Address:	8003 Overhill Rd., Bethesda	Meeting Date:	6/25/2025
Resource:	Contributing Resource Greenwich Forest Historic District	Report Date:	6/18/2025
Applicant:	Michael and Lisa Dobbs	Public Notice:	6/11/2025
Review:	HAWP	Tax Credit:	Yes
Case Number:	1118844	Staff:	Devon Murtha
PROPOSAL:	Window Replacement

MONTGOMERY COUNTY HISTORIC PRESERVATION COMMISSION STAFF REPORT

PROPOSAL

Figure 4: Proposed Pella Lifestyle windows to be installed on subject property.

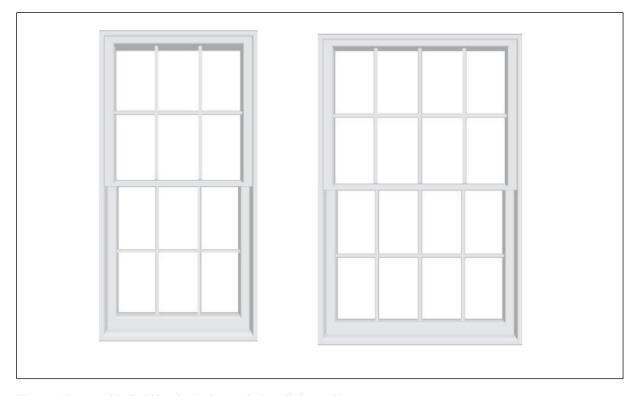
The applicant proposes to replace nine (9) double-hung wood wash windows with nine (9) double-hung aluminum-clad wood windows to match the existing profiles. The applicant proposes to install the new windows into the existing wood frames. Staff finds that the replacement windows are compatible with Chapter 24A and the *Greenwich Forest Design Guidelines*.

In considering the appropriateness of the proposed replacement windows, Staff looks to Guideline D17 and A2(C). The proposed double hung sash window replacements are generally compatible the overall character of the Colonial Revival revival style, satisfying this requirement. The muntin pattern matches the configuration of the existing windows, although Staff notes that the bottom rail of the Pella Lifestyle Series is slightly shorter than that of a typical early twentieth century wood window. The HPC has consistently interpreted Guidelines D17 to allow for a change of material in the Greenwich Forest

The applicant is proposing to install the replacement windows in the existing frames. In installing the new windows, the applicant must be careful to retain the relationship between the existing frame elements and the new windows. Any subframing elements should not be visible, as exposed subframing could create an additional "tiered" or overengineered appearance that would be incompatible with the historic character of the windows.

- 1. New windows must be installed so that that the following installation conditions are met:
 - a. They match the existing inset depth into the window openings
 - b. They replicate the existing relationship between the sash and frames. New sash should be installed so no added sub-framing is visible.
 - c. There is no capping of the window frames.
- 2. Shop drawings or other annotated drawings showing compliance with the above must be submitted prior to issuance of the HAWP.
